# TUFTS LIBRARY

## Pre-Proposal Designer Information Session

# Approved Schematic Design

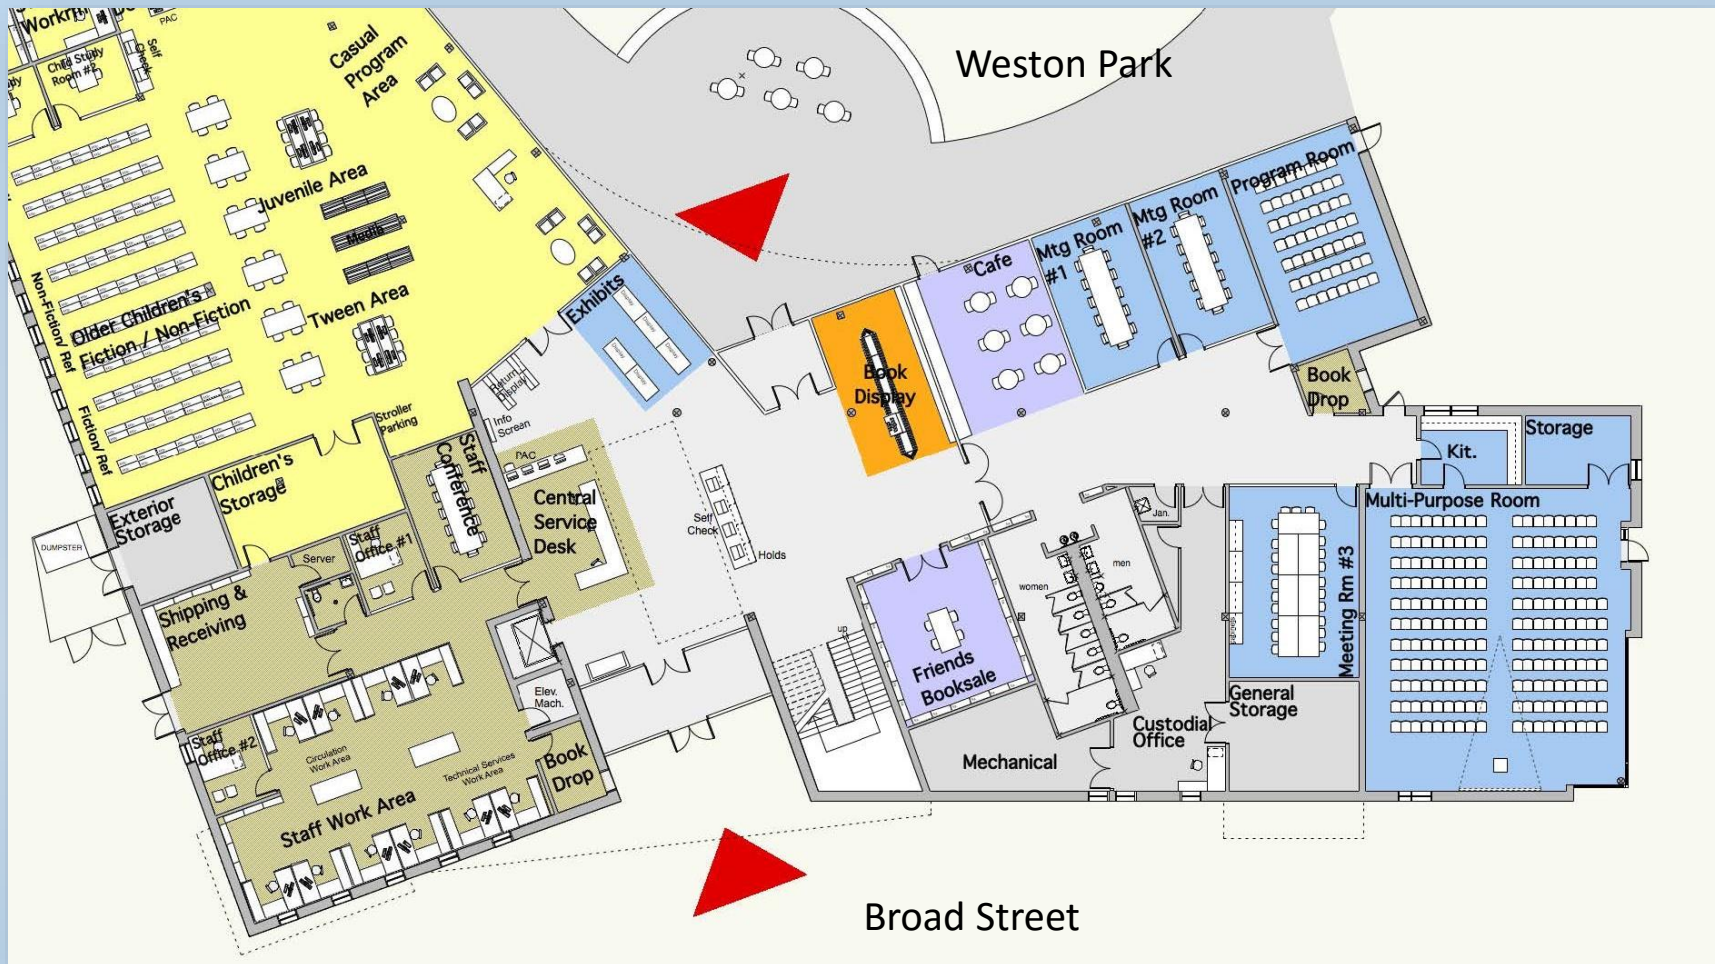
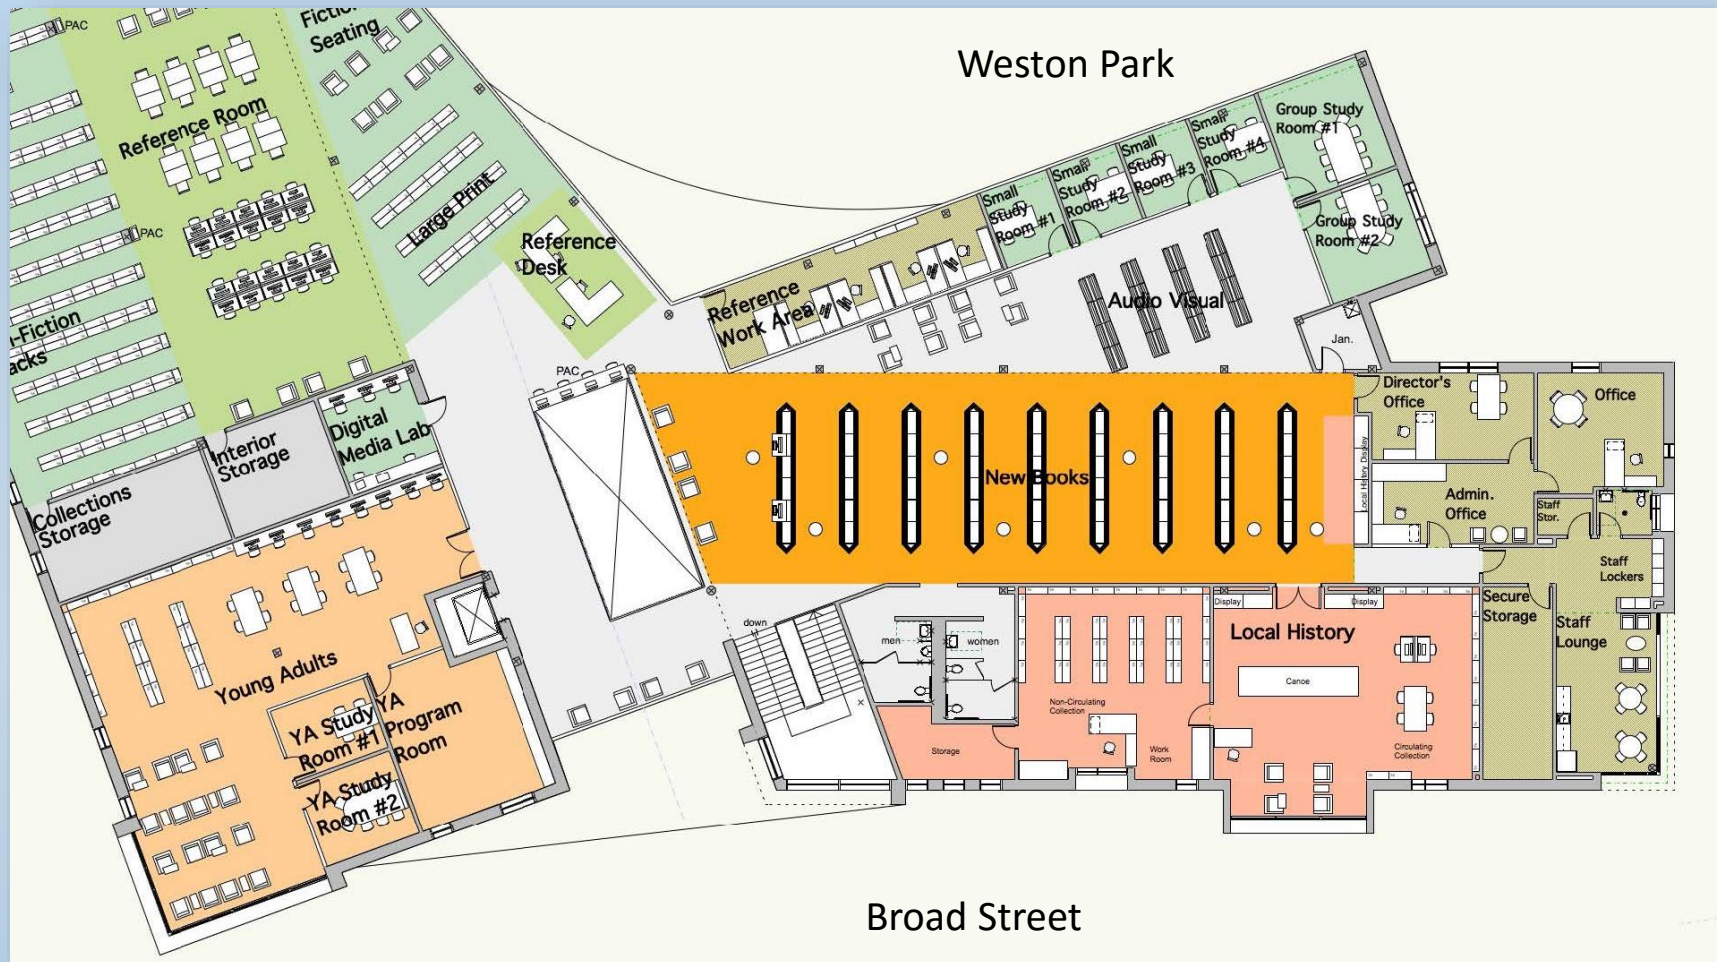
- Comments were minor:
  - ☐ Children's Librarian Office is too far back.
  - ☐ Stroller parking should be closer to the toddler area.
  - ☐ Add storage in the story-time room.
  - ☐ Use mobile shelving in the new materials section.
  - ☐ Move YA programming space to the other side of the room.
  - ☐ Sight lines are stretched to the max on the second floor.
  - ☐ Consider adding stacks with 7 shelves in adult fiction and non-fiction areas.
